From: [Ranelli, Matt](#)
To: [Maureen Fitzgerald](#)
Subject: RE: 51 Daniels Avenue wetland applications
Date: Tuesday, May 20, 2025 2:02:13 PM
Attachments: [image001.png](#)
[2025-05-20 LEARN Early Childhood School - Conservation Comments.pdf](#)

Thank you again for the site visit with Dean. We are attaching the revised drawings with changes to address the comments and concerns. There is a short sheet-by-sheet description of the changes below if it is helpful for your review. Please let me know if you want to discuss any of the changes – hopefully we hit the mark.

DRAWING NUMBER:
CE101

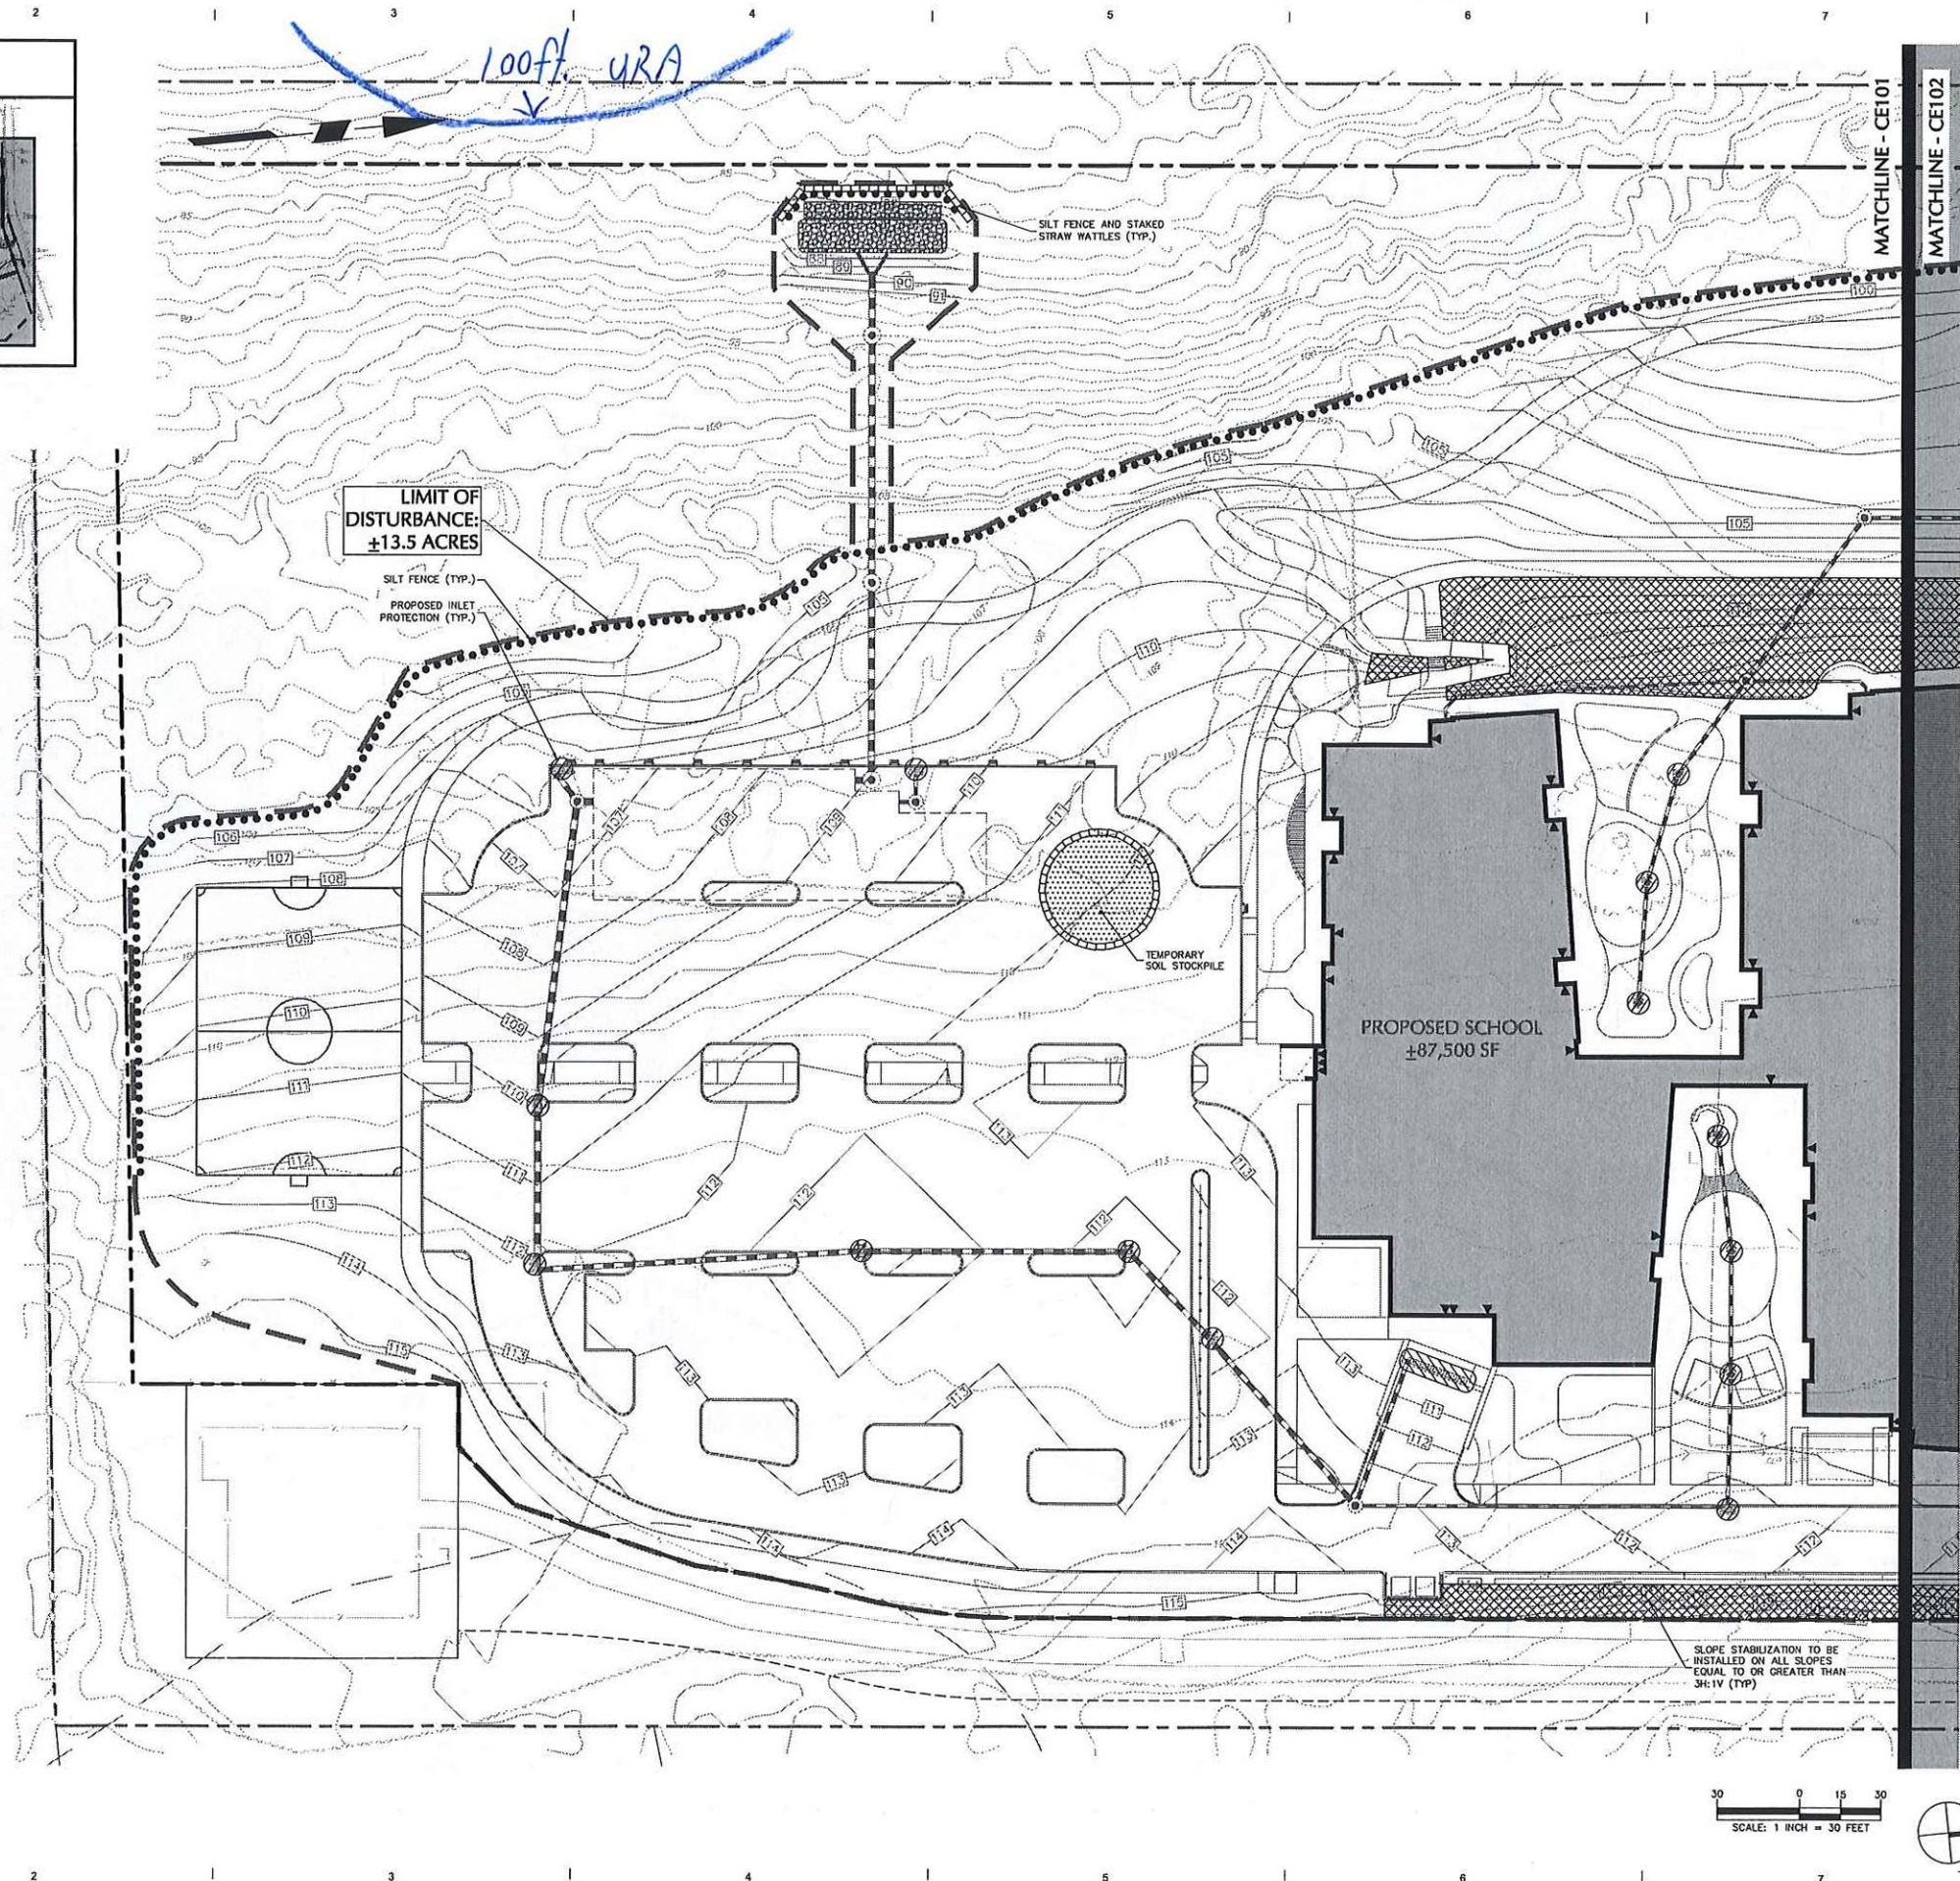
4. Sheet CE101 – Additional E&S controls have been provided for the relocated outfall.
5. We will provide the E&S phasing plan as part of the Planning and Zoning review (as well as being included later in the CTDEEP Stormwater GP submission) it will show the locations of temporary stormwater features (e.g., diversion berms, basins, etc.) which will be located outside of the 100' URA.

DRAWING NUMBER:
CG101

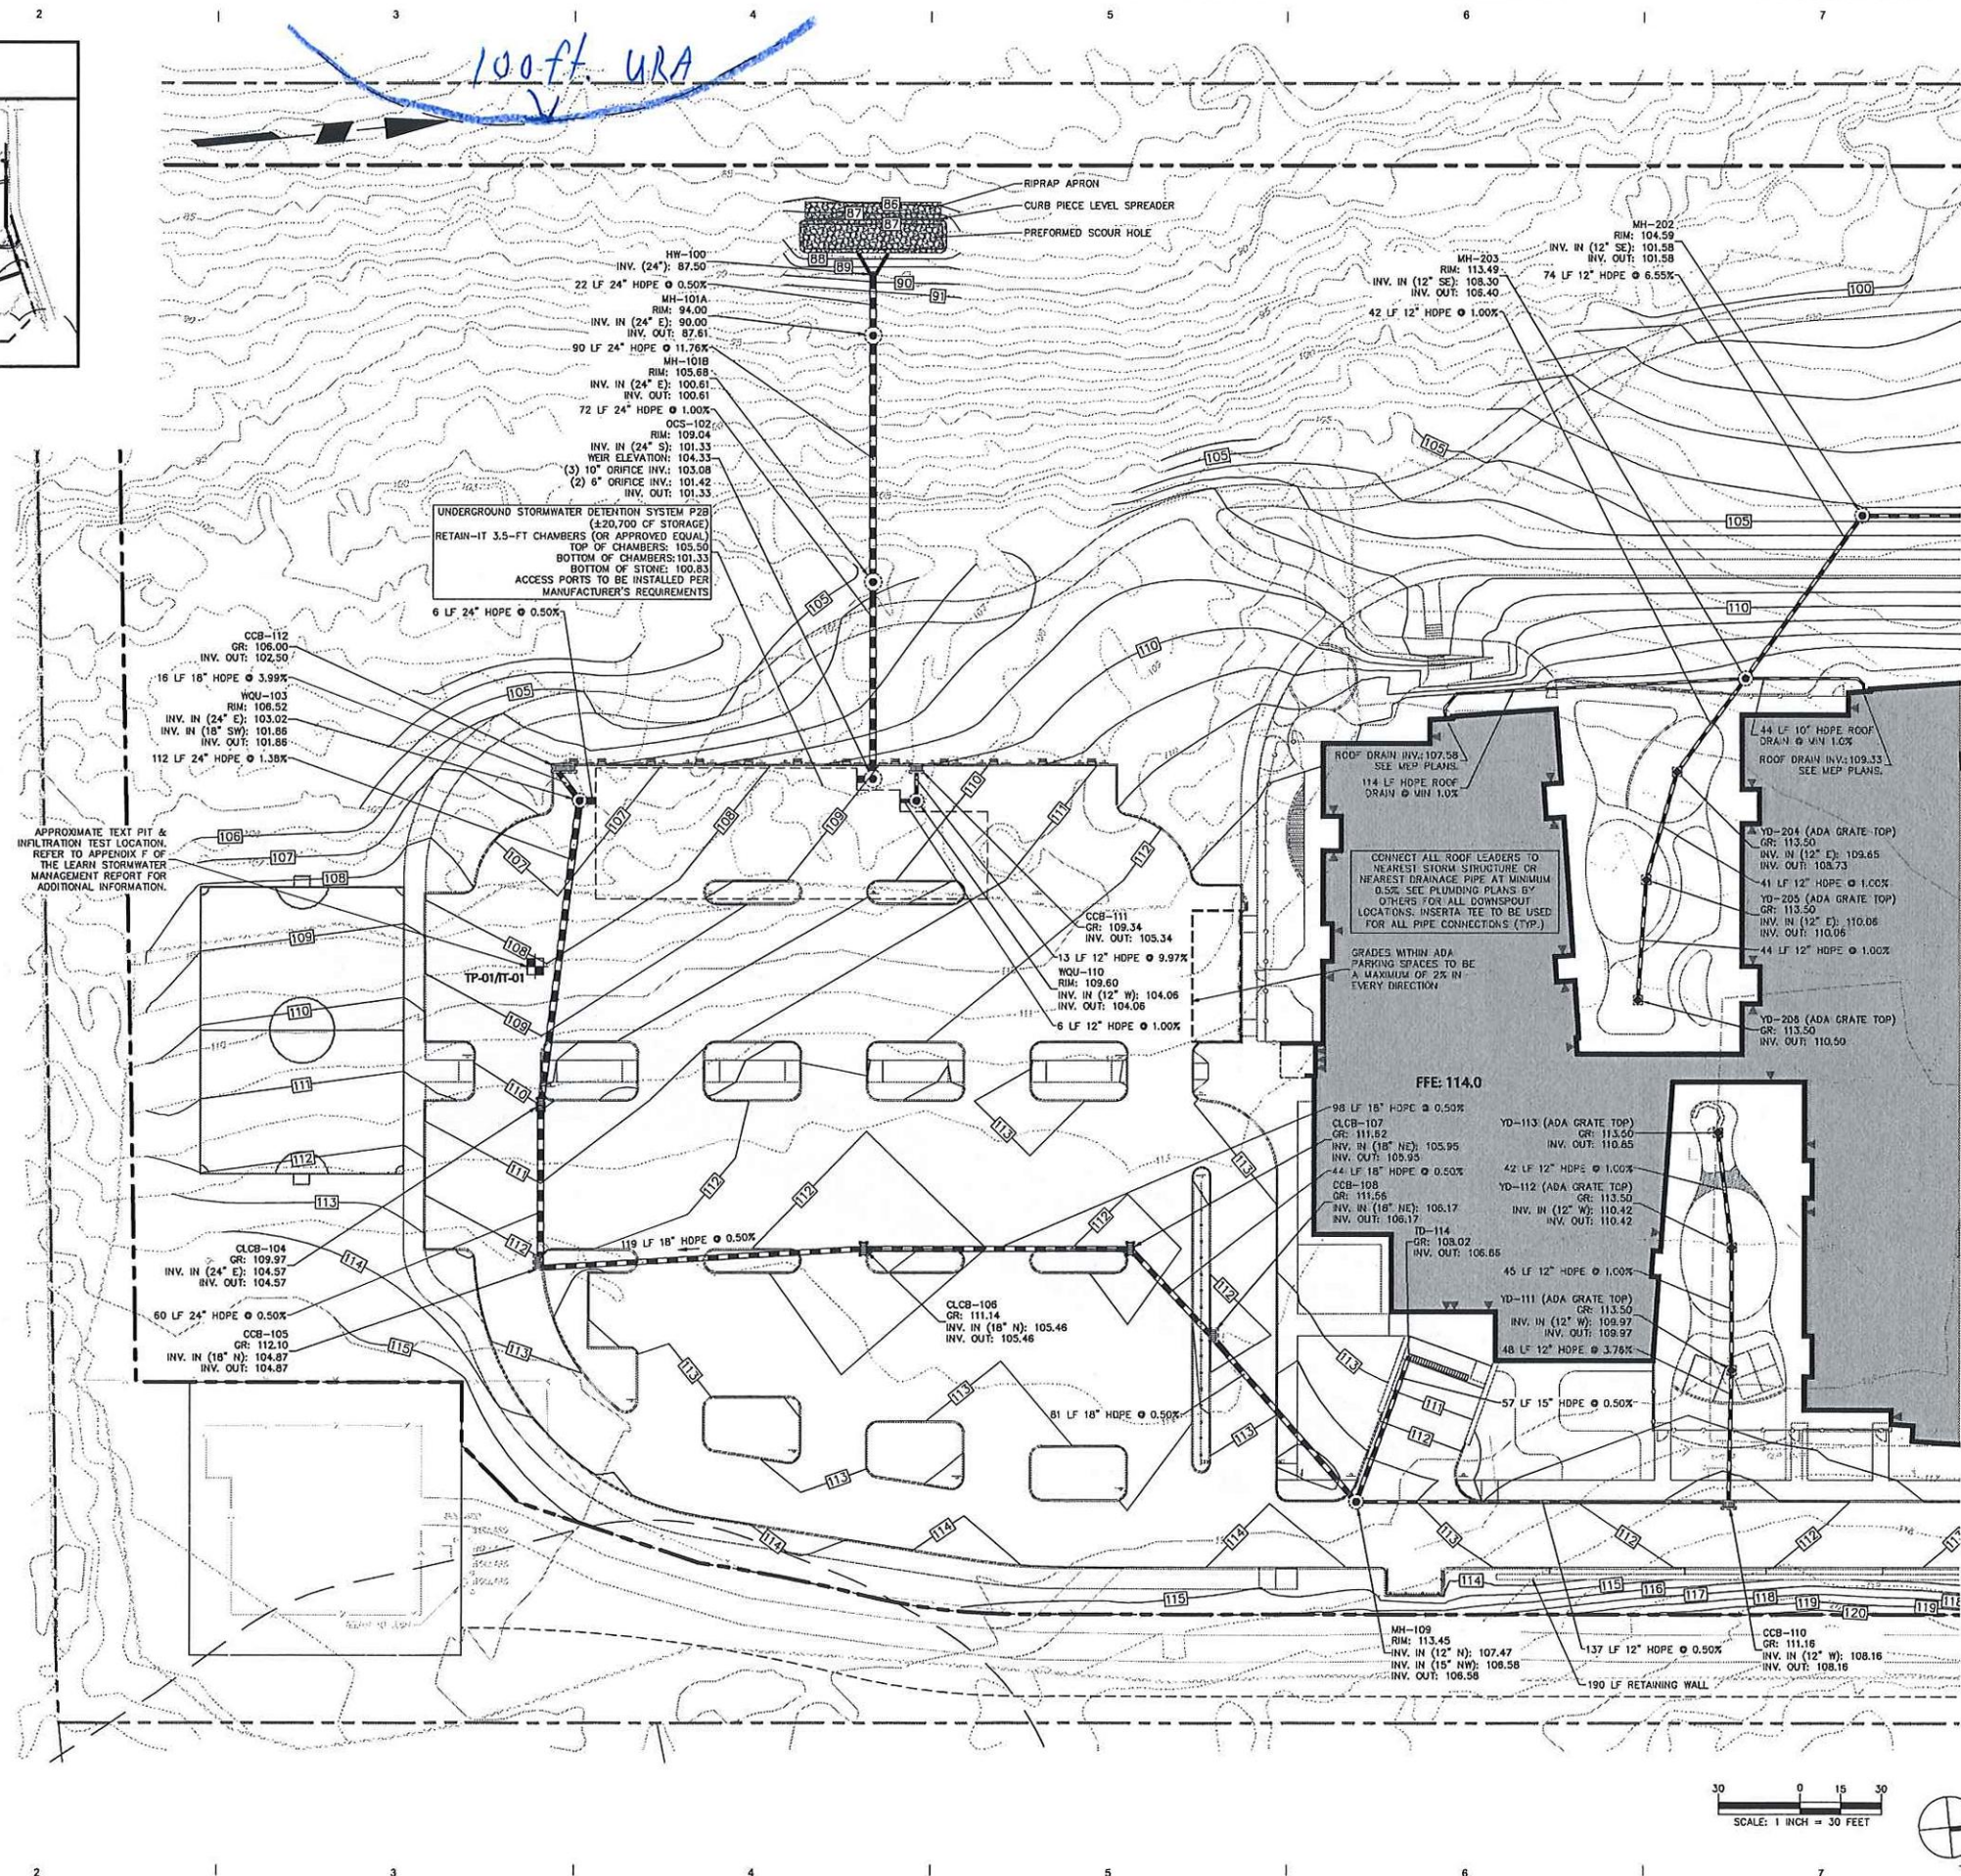
2. Sheet CG101 – We relocated the outfall to the suggested location provided by our wetland scientist after a recent site visit. The modified outfall includes a drop manhole structure, concrete headwall, rip rap scour hole and 50' long level spreader to provide energy dissipation and promote unconcentrated flows. The discharge location is relatively flat area and is located outside of the 100' URA for Wetland 3. We confirmed with Dean that this outfall location will not adversely impact wetland 3.
